Service Bulletin

Issue No	VZR1800-24
Date	22/06/2010
Page	1 of 1

Subject	THROTTLE CABLE O-RING INSTALLATION
Applicable Model	VZR1800K6-K7
Effective Engine or Frame No	
Reference	SERVICE MANUAL:99500-39293-01E SET-UP MANUAL:99505-01096-01E

- A Throttle cables
- B O-ring
- C Clamp L. 90mm
- D Headlight stay

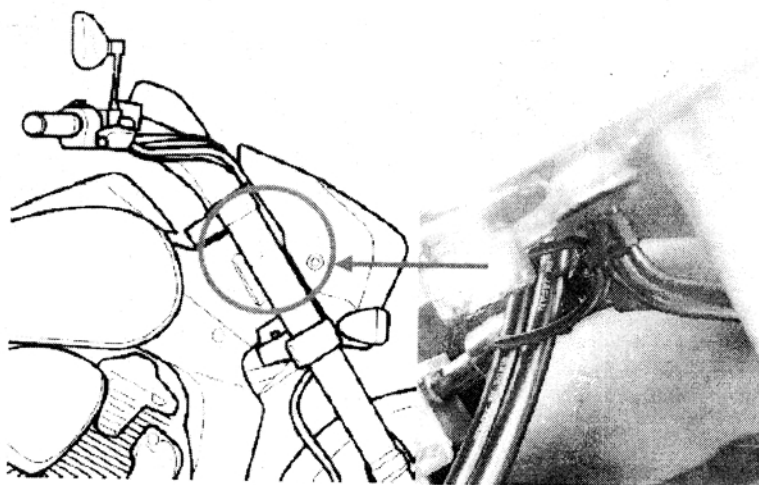
This bulletin is to inform you of the proper installation of the O-ring used to located and secure the throttle cables on the VZR1800K6-K7 models. Information received from the market has found that the O-ring may not have been installed at the time of new vehicle set-up, or was removed by service during routine maintenance or repairs.

Correct installation of the O-ring and the throttle cables correctly routed through the cable guide ensures smooth operation of the throttle cables when the handlebars are turned to the full lock position.

When setting up a new vehicle, make sure to correctly install the O-ring packed in the carton box located in the crate, by following the procedure outlined in the appropriate **Assembly and Pre-Delivery Service Guide. 99505-01096-01E**

When performing routine maintenance or repairs on a customer's VZR1800K6-K7 check the installation of O-ring and inspect the throttles cables for correct routing. Correct any discrepancies found before returning the unit to the customer. Additionally verify that the O-ring is properly installed on the new and used VZR1800K6-K7 models in your inventory prior to customer delivery.
